fremont place

2018-05-10
city council hearing

process overview.

evolution overview.

revised section at greenway
showing a total of 17'-6" of additional width from proposed design changes

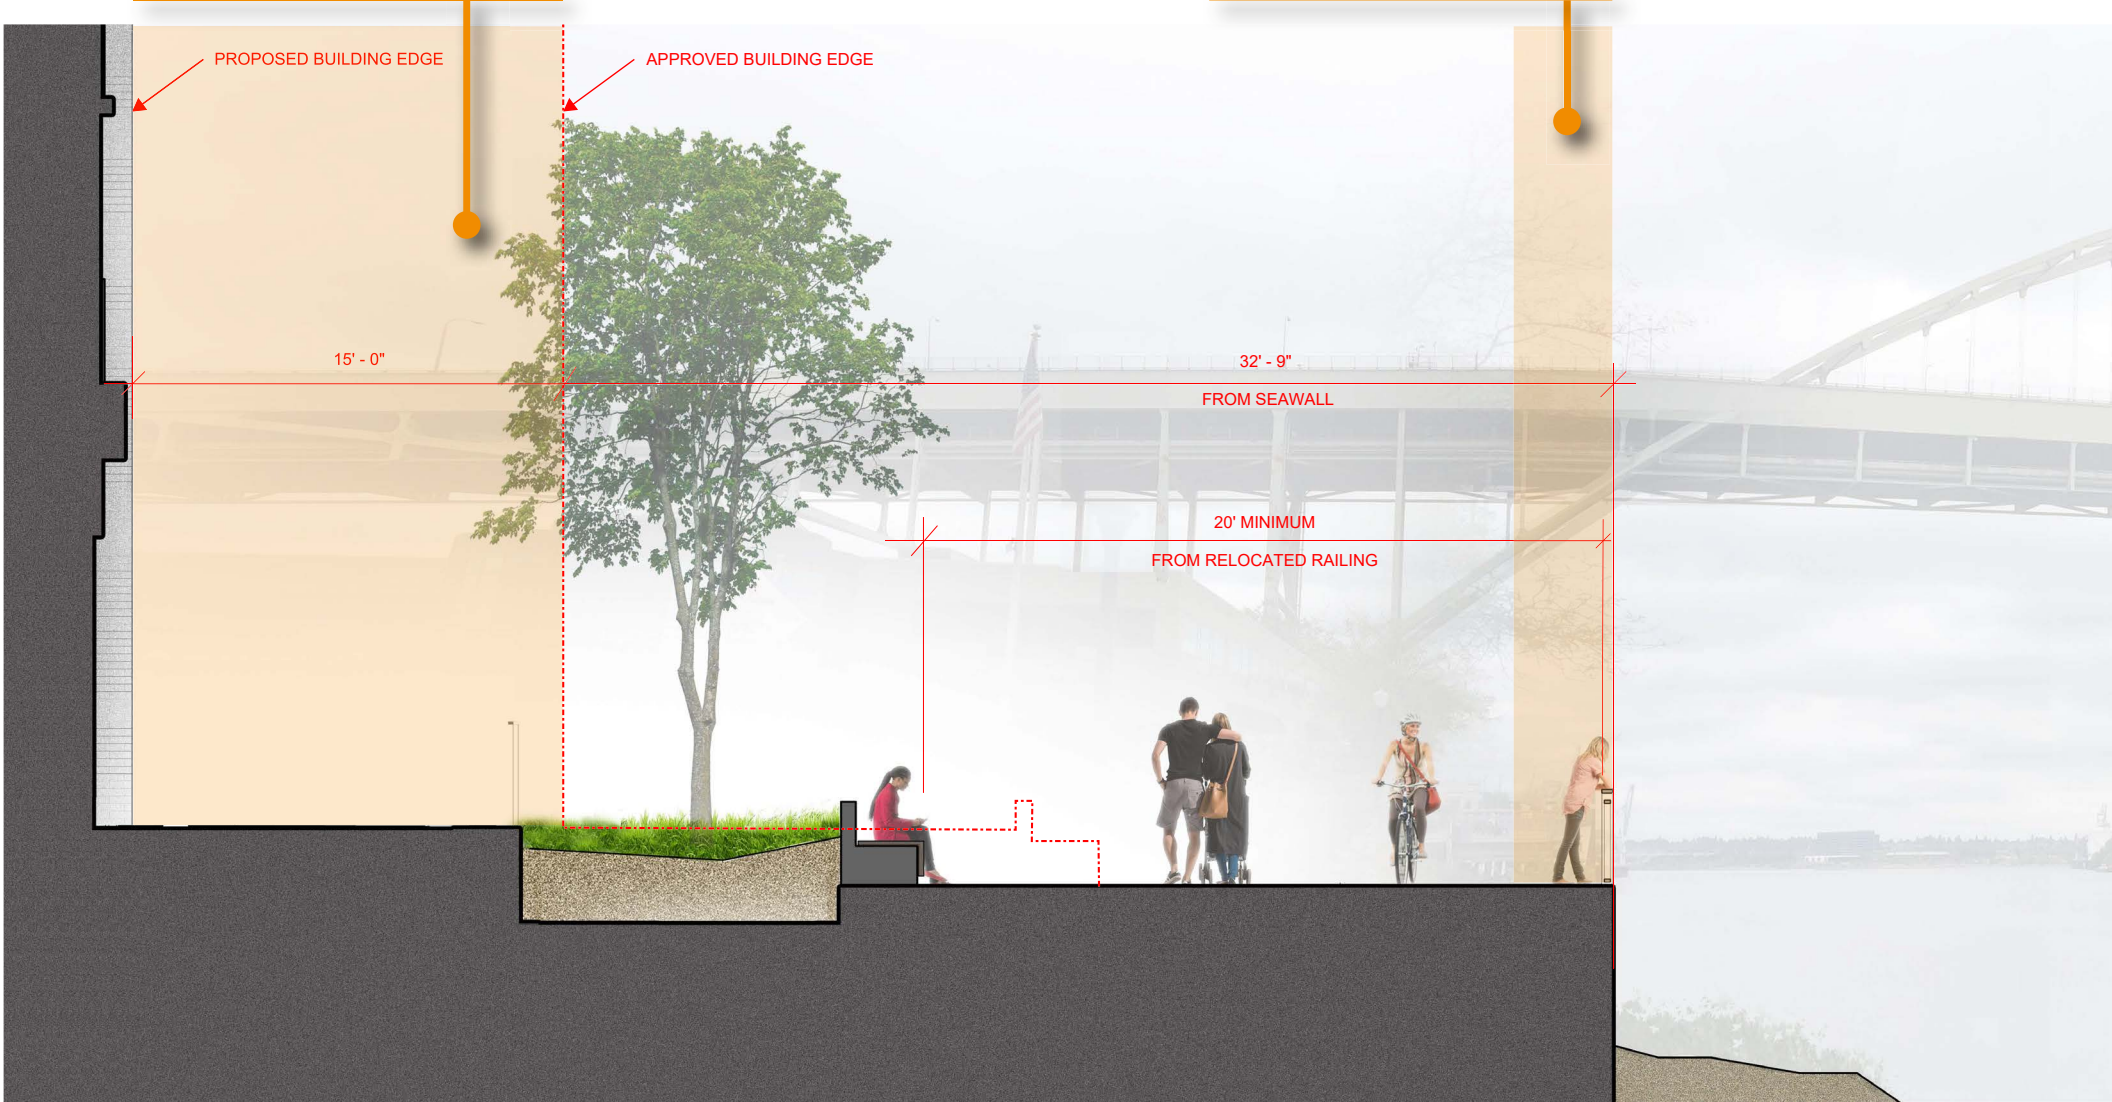
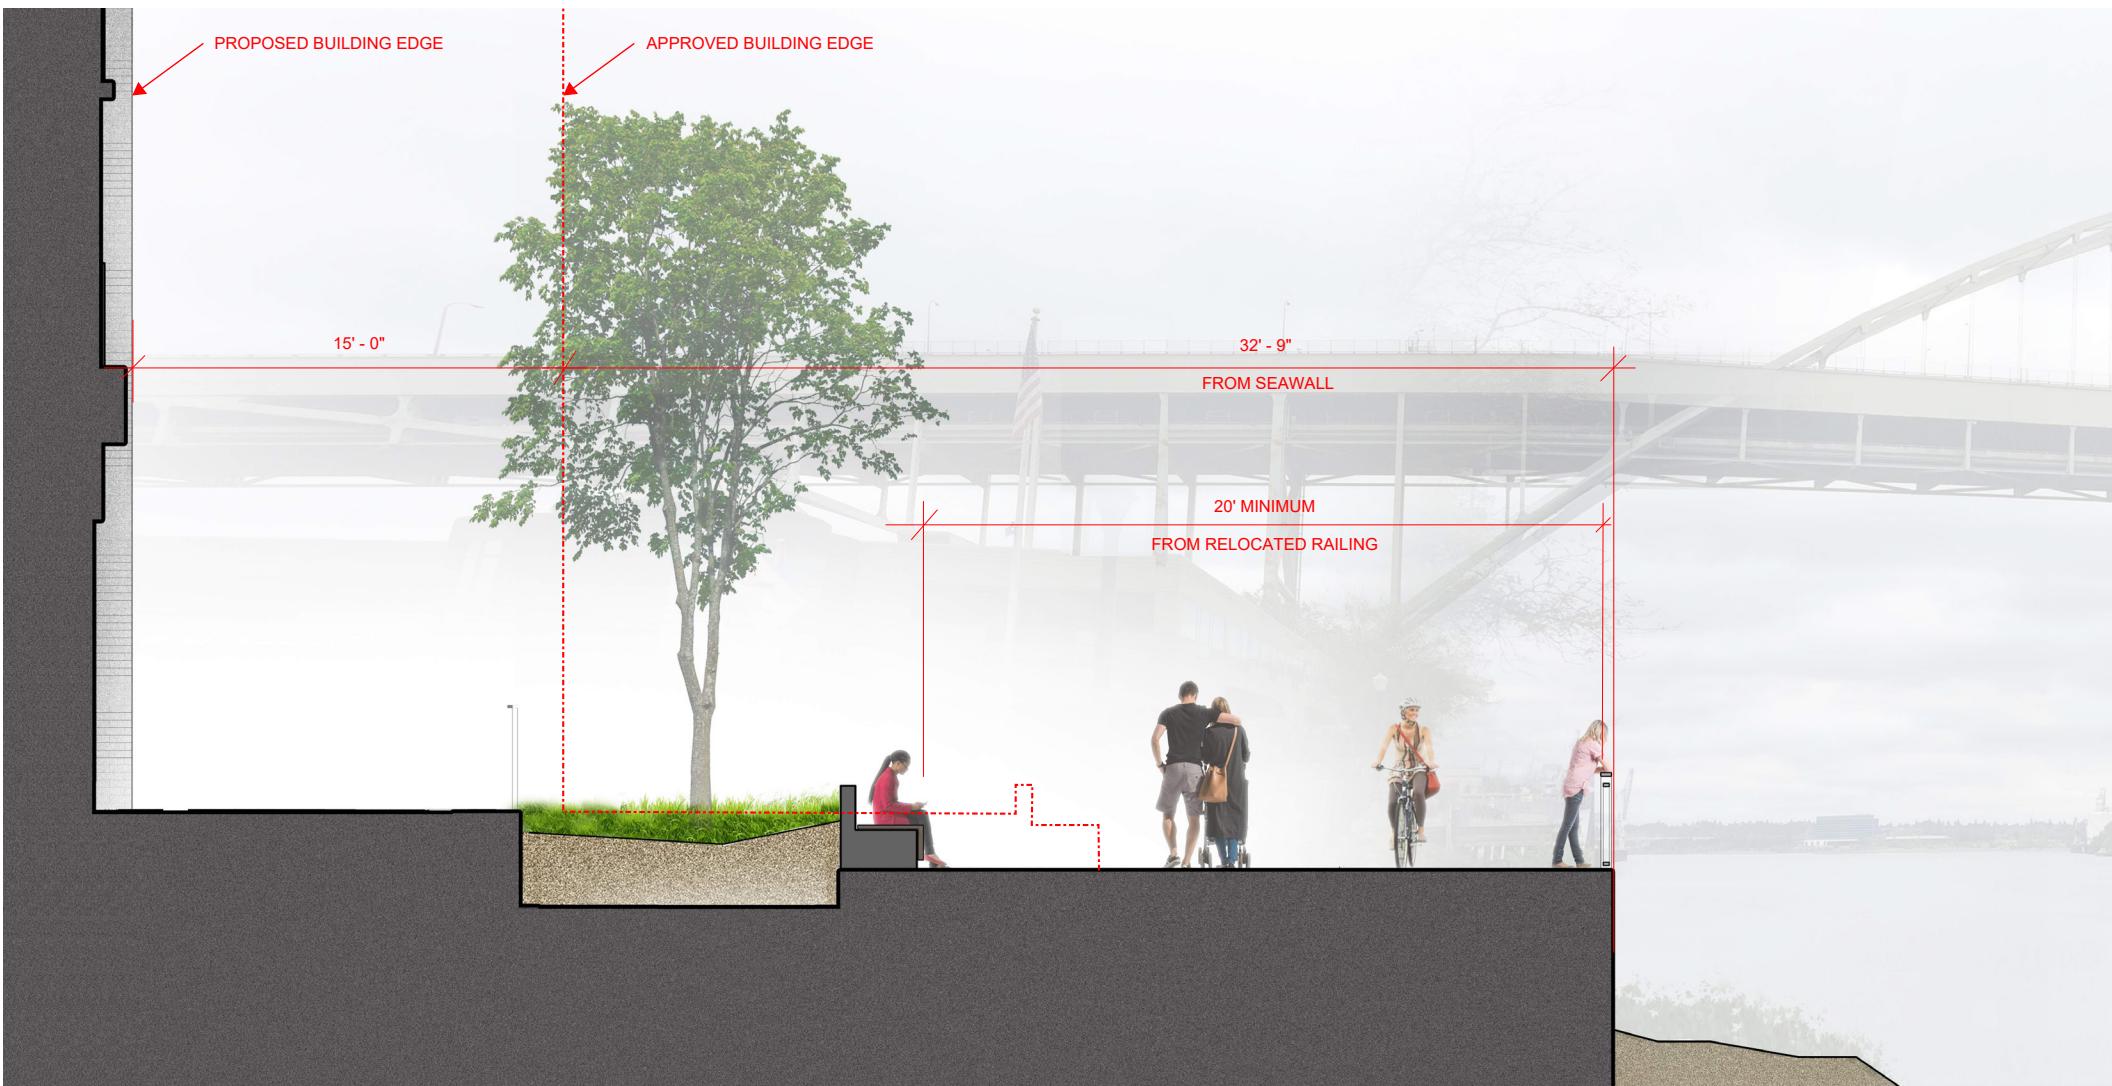
area of additional building setback

additional useable public space at relocated guardrail

closest point of building to seawall in modified design

minimum walkway width in modified design

43'-4"

20'-0"

proposed design revisions (plan view):

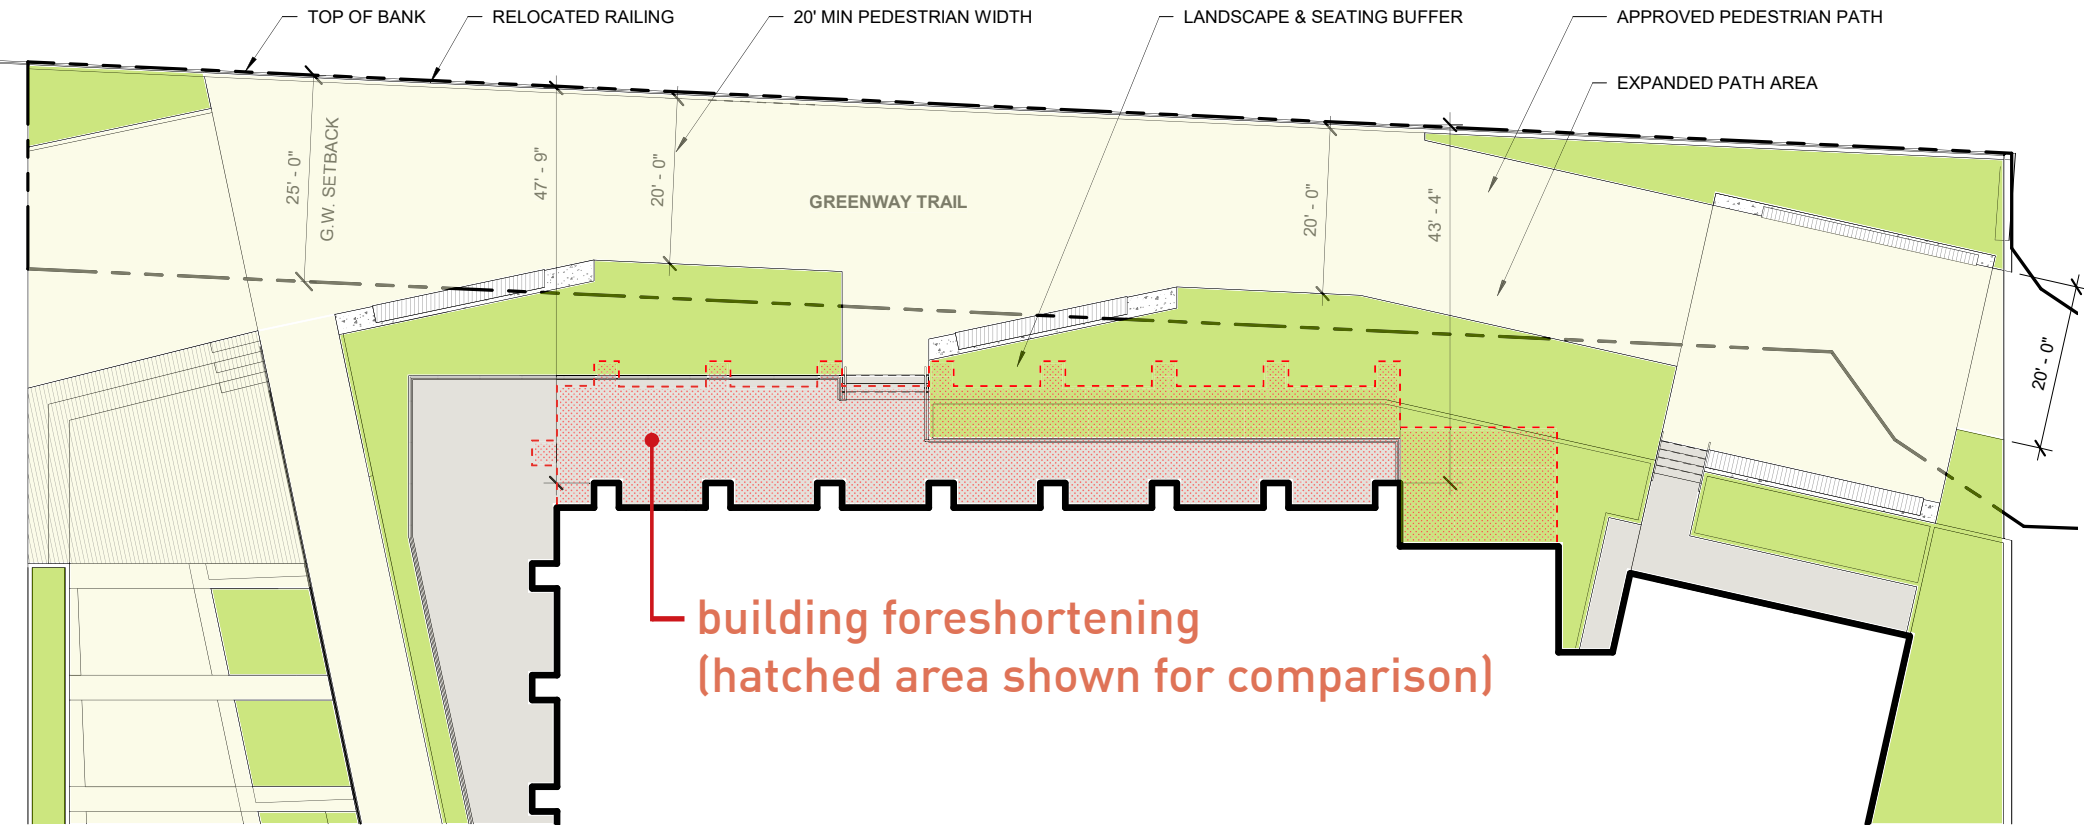
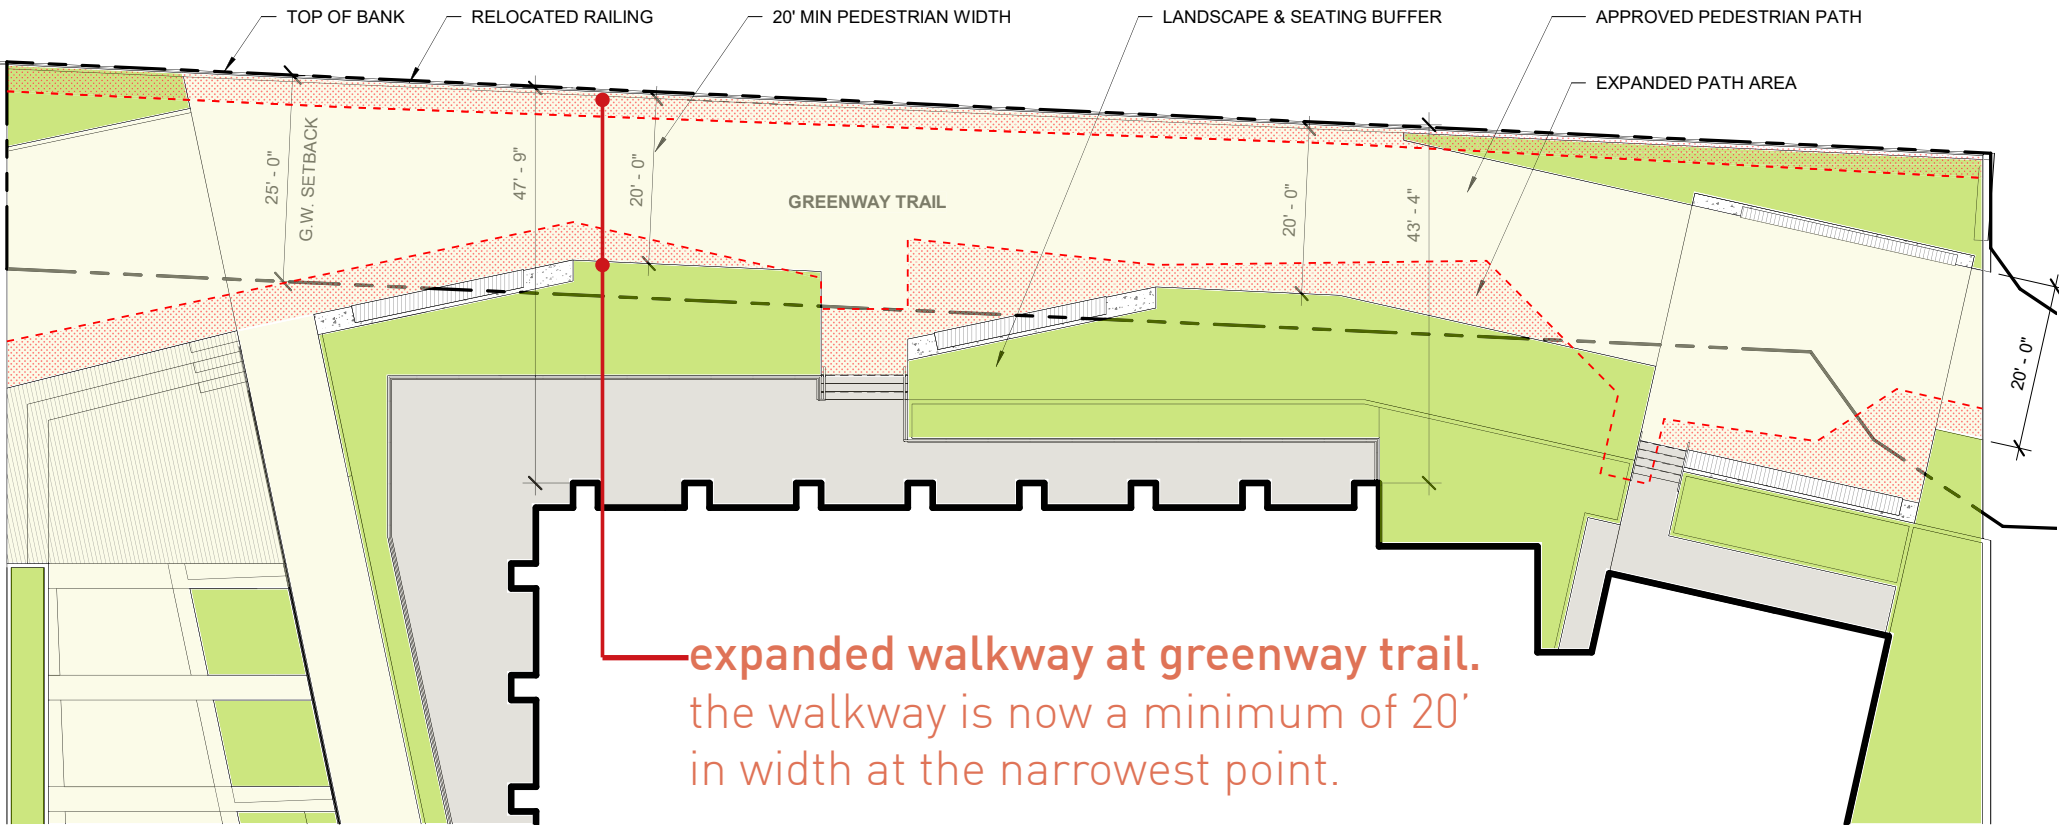
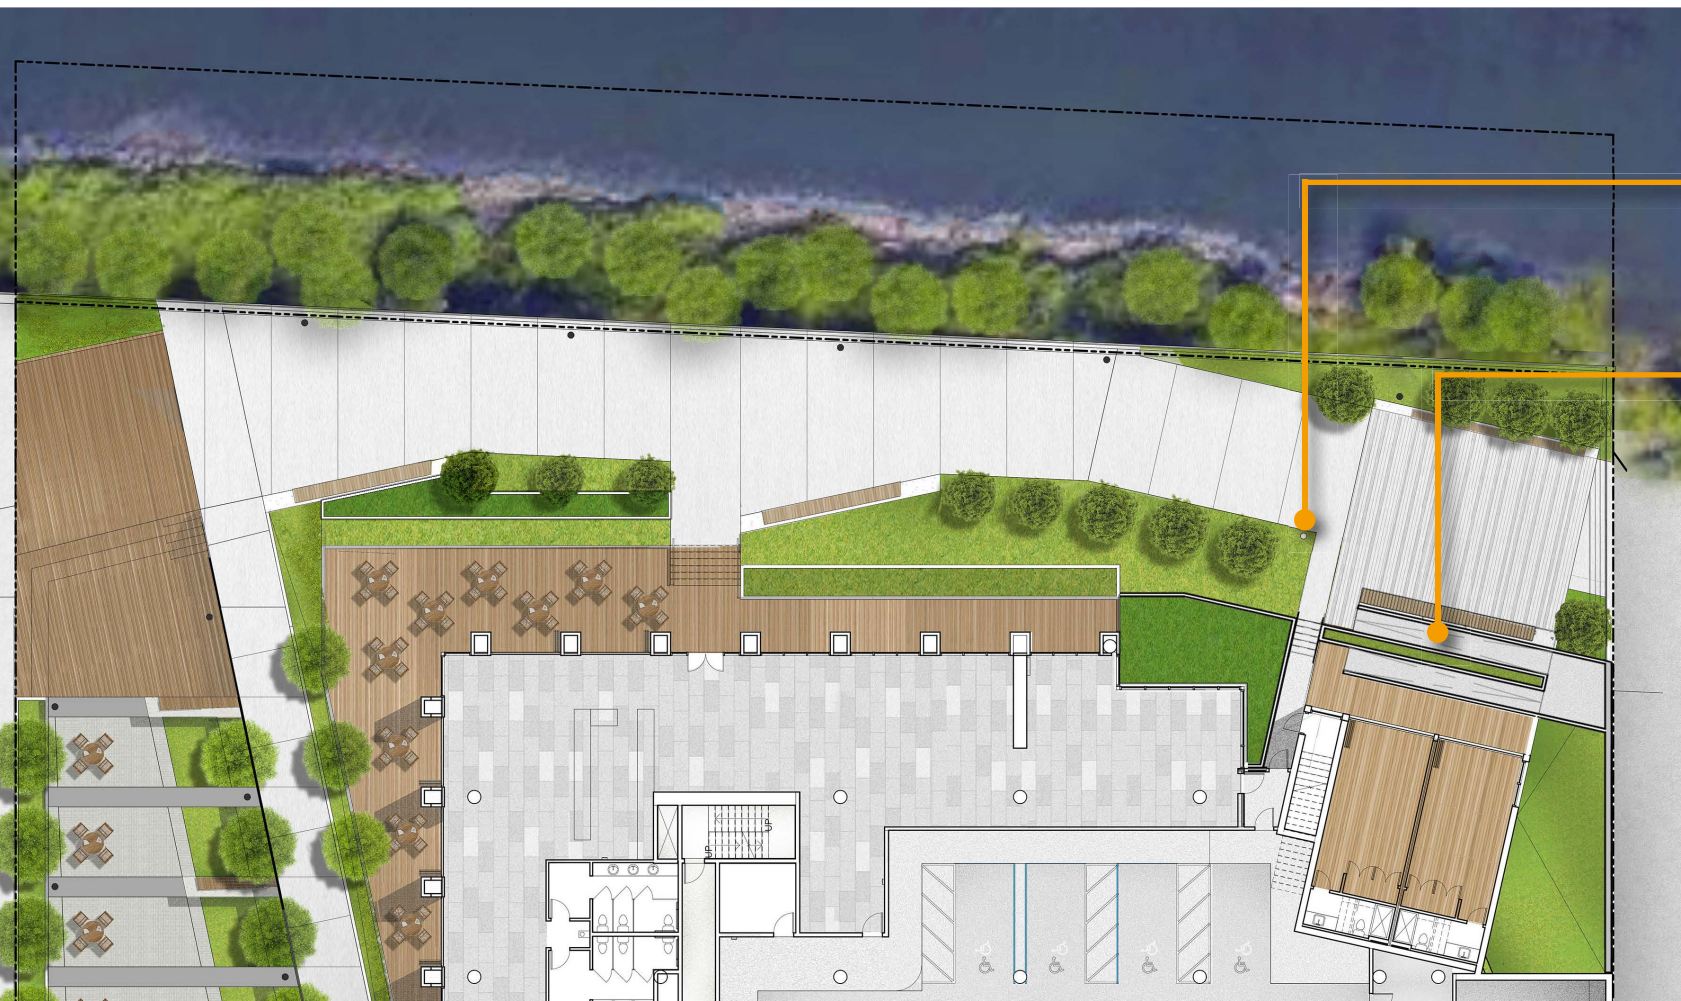
revised design
(per bds input)

drinking
fountain
added

accessibility
issues
addressed

proposed design revisions
(north elevation)

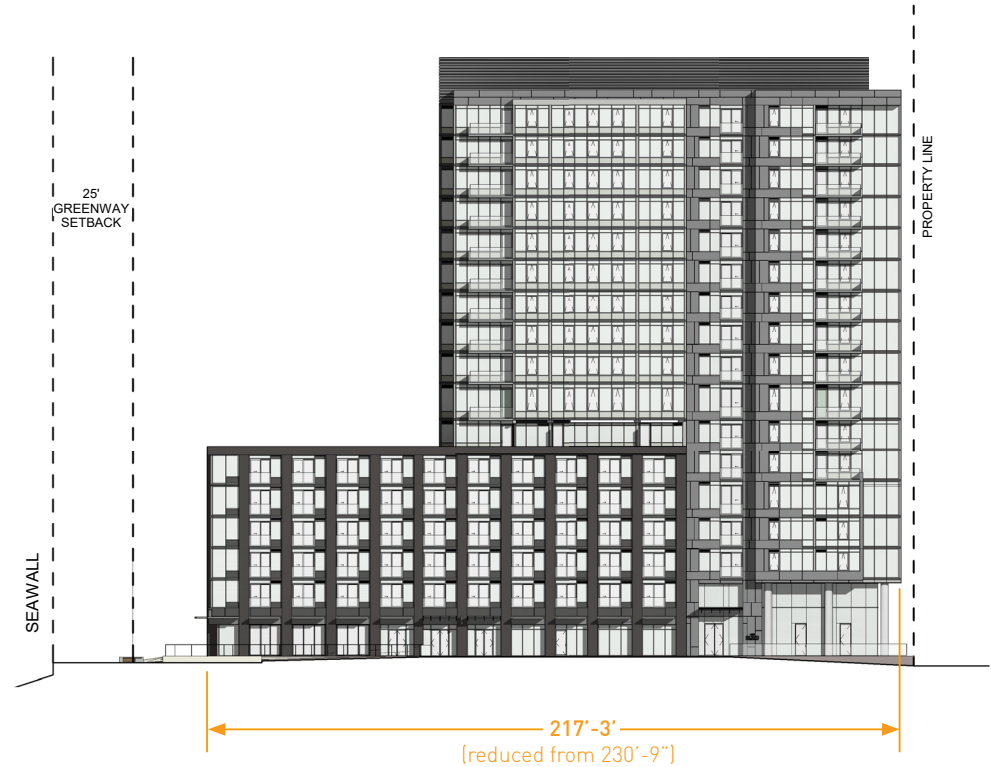
dimension:
building maximum length between greenway & naito

bike storage reconfiguration: bike racks meet code standard 2'x6'

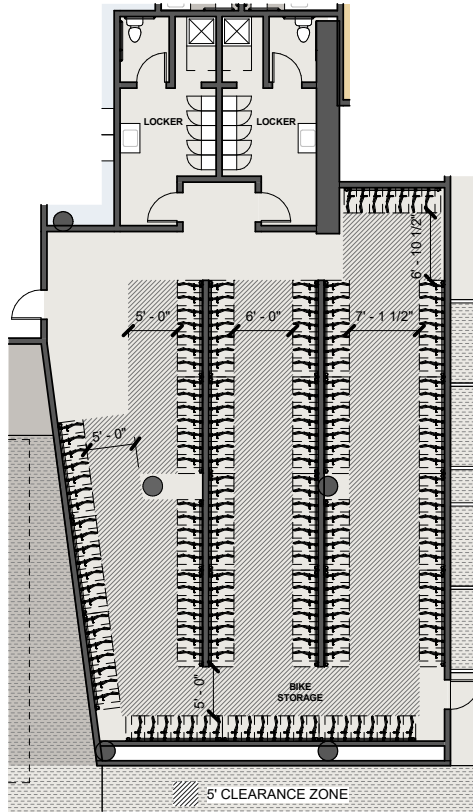
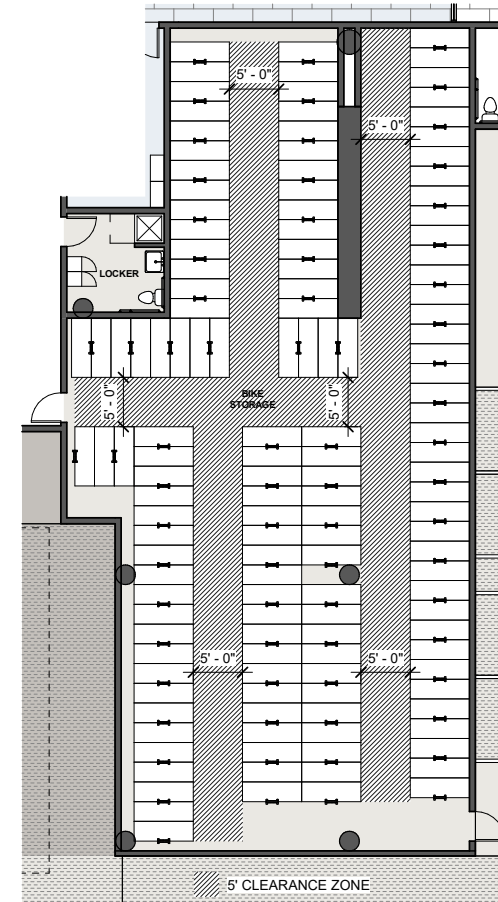
approved
(206 BIKES)

proposed
(140 BIKES)

**TOTAL PROVIDED = 275 IN UNITS + 140 IN BIKE STORAGE
= 415 SPACES @ 2' X 6' SIZE**
